REMARKS

This is a preliminary amendment to be entered with a Request For Continued Examination, and represents a full and timely response to the Advisory Action mailed on July 2, 2004 and the final Office Action mailed on April 9, 2004. Through this preliminary amendment, claims 1, 4-5, 11, 14-16, 23-25, 28-30, and 35-37 have been amended, and claim 31 has been cancelled without prejudice, waiver, or disclaimer. Reconsideration and allowance of the application and pending claims are respectfully requested.

FIGURE 3A

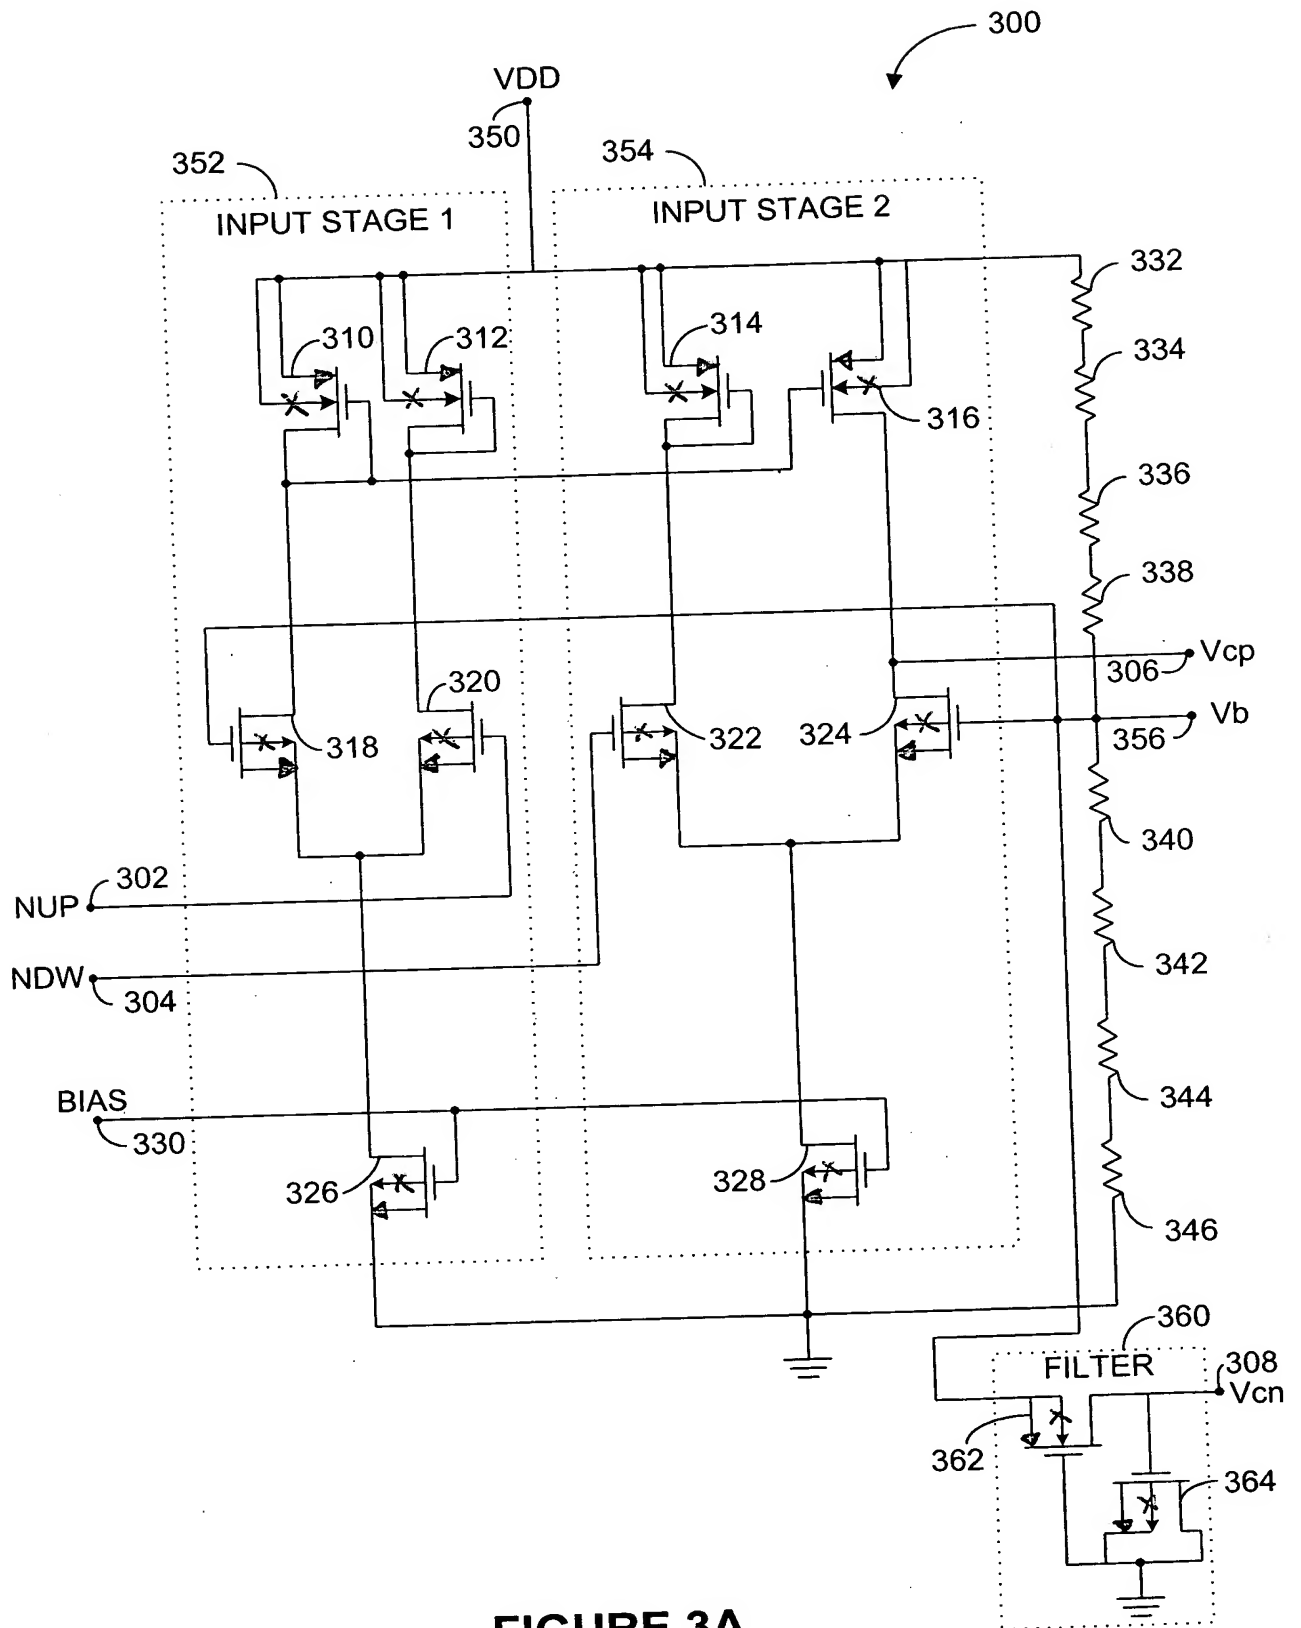
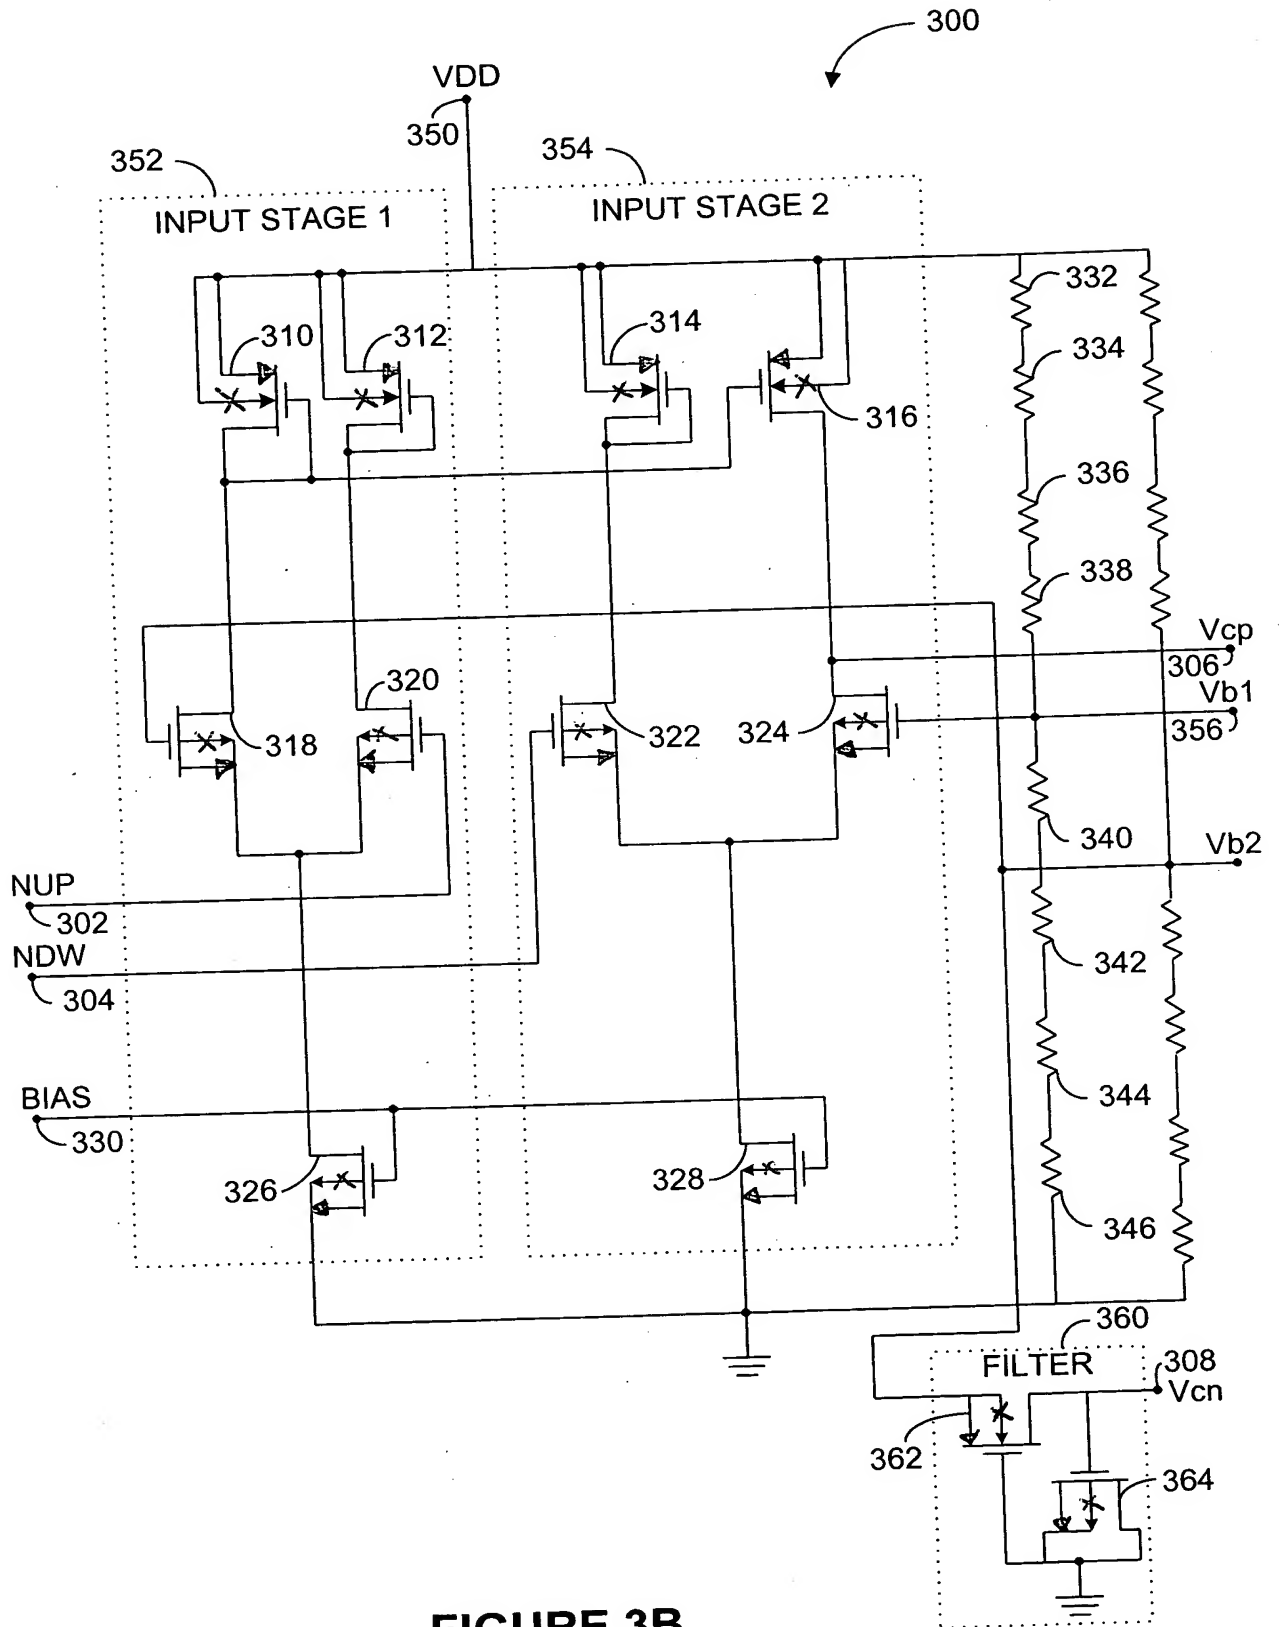
Examiner has considered Applicant's remarks for the drawing objection and has not found them to be persuasive. Contrary to Applicant's remarks, it would have been clear to one skilled in the art that, due to the direction of the area, the transistor 362 of Figs. 3A and 3B is in fact shown as an N-channel and that transistor 364 is in fact shown as a P-channel. Similar, due to the direction of the arrows for the remaining transistors, such are deemed to be improperly shown. Thus, the drawing objections have not been overcome.

Relating the above to a couple of examples of transistors represented in Applicant's drawings, please refer to FIG. 3A, transistor 362. As shown, the transistor 362 takes on a configuration as shown in Exhibits A and B for PMOS transistors. In other words, the arrow representing the substrate is pointing toward the gate, from source to drain. The fact that the source is from the voltage divider side (*e.g.*, from resistor 346) is reflected in the specification on page 14, lines 1 and 2. Thus, transistor 362 is shown in one embodiment as a P-type, enhancement mode transistor where the substrate is connected to the base.

As another example, please refer to FIG. 3A and transistor 364. Transistor 364 takes on a configuration as shown in Exhibits A and B for an NMOS transistor. That is,

the arrow points away from the gate, in a direction from drain to source. Such a configuration is known to those skilled in the art as an enhancement mode NMOS transistor where the substrate is connected to the body.

Applicant has amended the figures to comport with enhancement mode transistor designations where the body is connected to the substrate, as disclosed in several embodiments of Applicant's application. Additionally, Applicant has enclosed Exhibits A and B for the convenience of the Examiner and to support the drawing changes that have been made. Exhibit A includes two pages from a textbook used in a course presented at a university campus on analog and digital based microelectronic circuit

Thus, in that the drawings comport with accepted practice in representing transistors, Applicant respectfully submits that the objection to the drawings has been overcome. Further, Applicant respectfully requests that the drawing objections be withdrawn.
